DATE: March, 2007
DRAWN BY: DAR
APPROVED BY: DAR
P.S. No. 7597

HSM BUILDERS
MADISON MEADOWS SUBDIVISION
Site Plan For Sublot 34

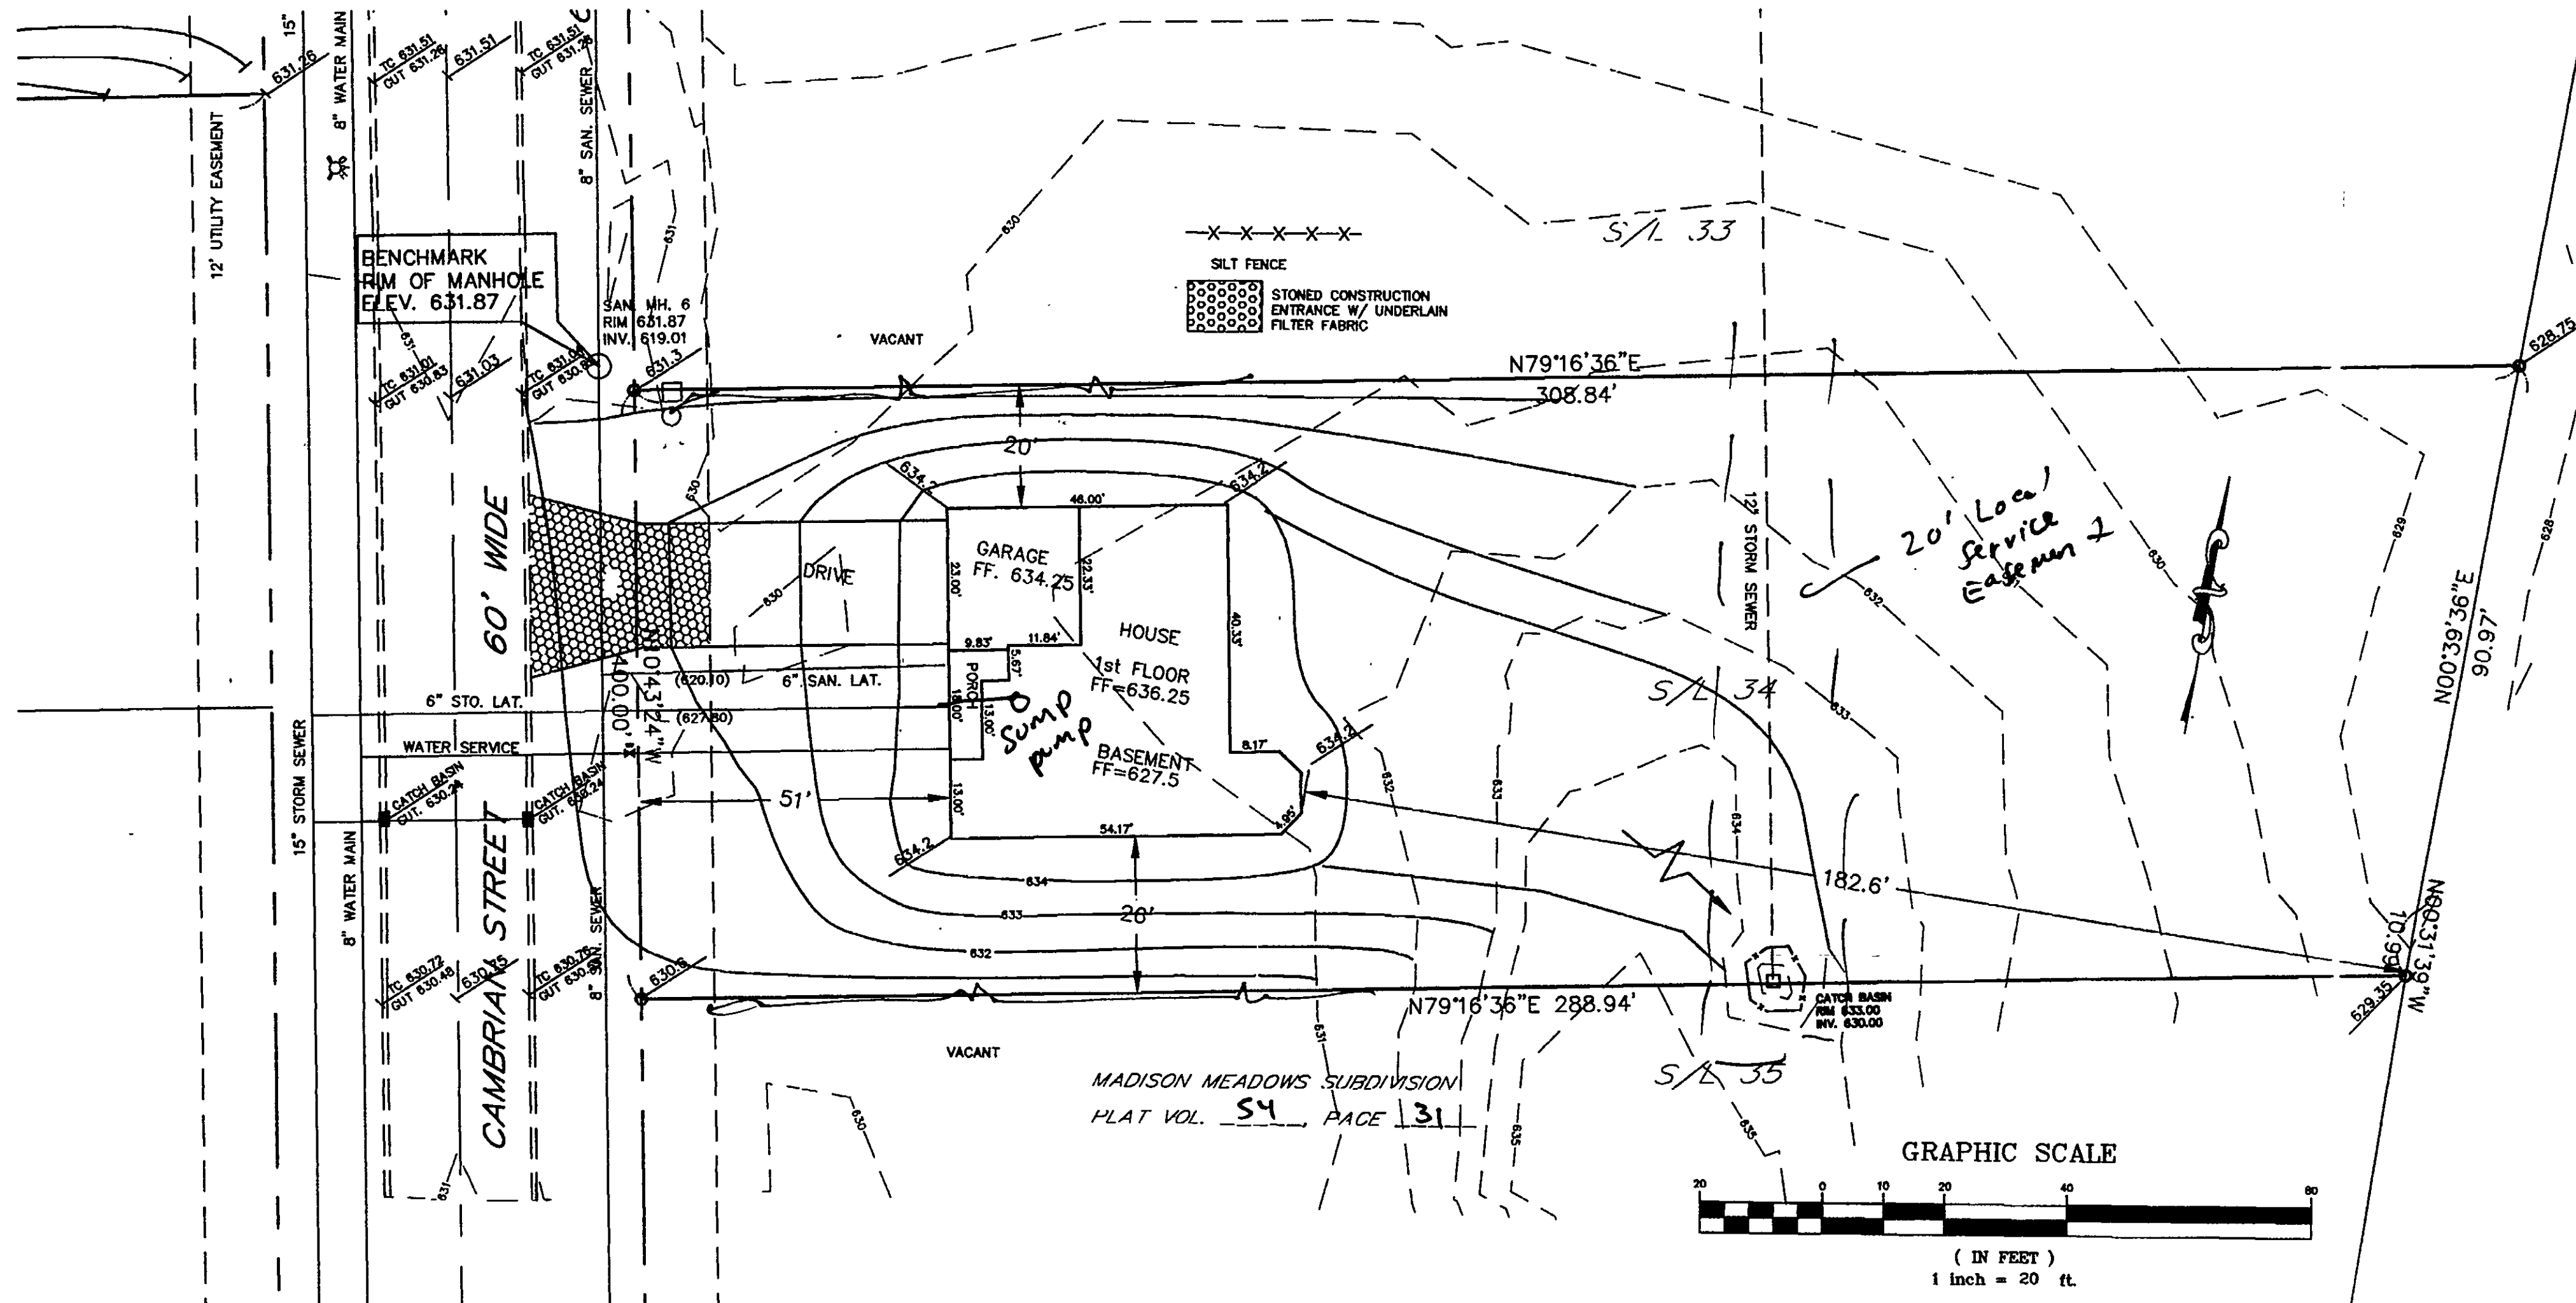
Management Plan
as shown and/or noted.
JAMES R. GILLS, P.E.
County Drainage Engineer
By *W.H.* Date *4/5/07*
Swale along property lines
Discharge Sump pump to
Storm lateral.
